Product Change Notification / SYST-28DSPA532

ERRATA - PIC18F27/47/57Q43 Silicon Errata and Data Sheet Clarifications

SYST-28DSPA532

PIC18F27/47/57Q43 Silicon Errata and Data Sheet Clarifications

1.7 Module: Universal Asynchronous Receiver Transmitter (UART)**1.7.1 UART TXDE Signal May go Low Before The STOP Bit Has Been Entirely Transmitted.**

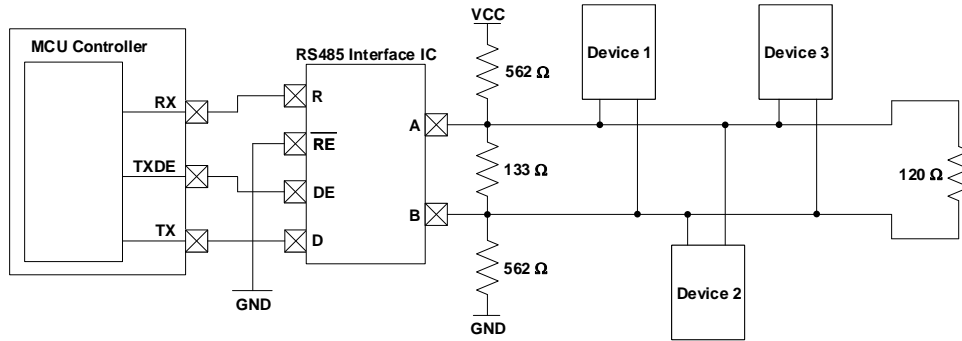
The UART Transmit Drive Enable (TXDE) signal could potentially transition into a low state before the UART STOP bit has been entirely transmitted due to the effects of parasitic capacitance on the TX line. In some applications, this could result in communication being prematurely terminated due to the TXDE bit going low before the STOP bit has had enough time to settle.

In order to ensure that the STOP bit settles into its final logic state before the TXDE signal transitions low, a biasing circuit can be implemented. A biasing circuit allows the TX line to either be driven high or low, rather than being left in a floating tri-state mode where prolonged rise or fall times could lead to communication being disrupted. This bias circuit should only be implemented on one end of the serial bus, and a termination resistor should be used on the other end. The figure below show an example of a bias circuit that can be used to achieve this.

Please note that the resistor values used in this circuit are recommendations, and that the actual resistor values required may vary based on the application.
